UNITED STATES PATENT AND TRADEMARK OFFICE

APPLICATION NO.	FILING DATE	FIRST NAMED INVENTOR	ATTORNEY DOCKET NO.	CONFIRMATION NO.
09/841,094	04/25/2001	Rudolf Seiz	Q63688	4971

Office Action Summary

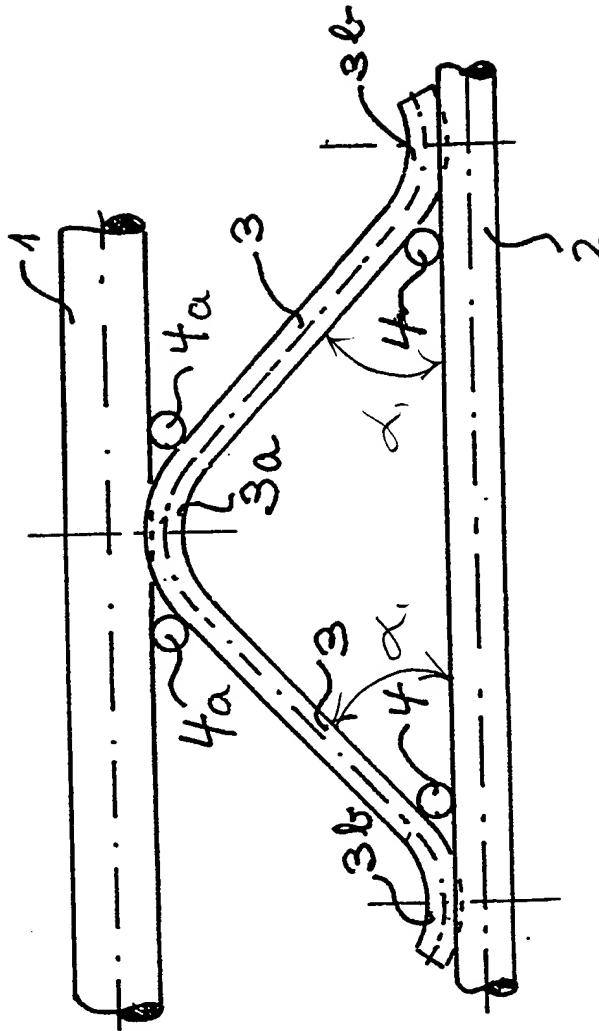
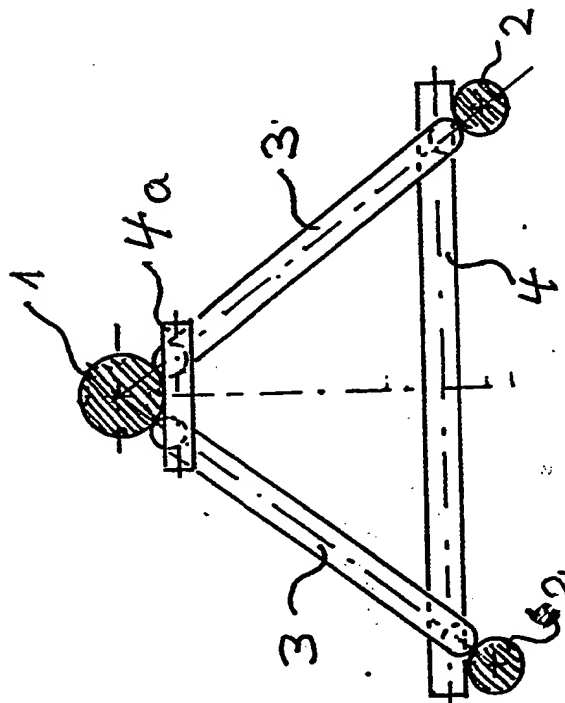
Truss does not attach to lower boom with a curved or bent portion.

1. The specification is objected to as failing to provide proper antecedent basis for the claimed subject matter. See 37 CFR 1.75(d)(1) and MPEP § 608.01(o). Correction of the following is required: The specification does not clearly detail what is meant by attaching the truss members to the lower boom members “without bending”. Is without bending referring to the truss braces themselves not being bent or the truss braces not bending about the boom members. Clearly, the truss braces are bent as at curve (3b). Clarification is required.

Further, it is not clear how the truss members are attached “without bending” when it is detailed that each truss member have a curved part and a straight part. The curved part is a clear indication of “bending”. Clarification is required.

In regards to the applicant's argument that the truss members of DE 19111627 are not attached to the boom members without bending, the step of bending is a method step. The method of forming a device is not germane to the issue of patentability of the device itself. Thus, the step of attaching without bending has not been given patentable weight. Further, it is not clear what applicant intends by "attachment without bending". Is "attachment without bending" referring to the truss braces themselves or the to the truss braces about the lower boom. It is clear from the drawings and the specification that the truss members each have a curved portion (3b). Surely, this is a bend. Thus, there must be some type of bending.
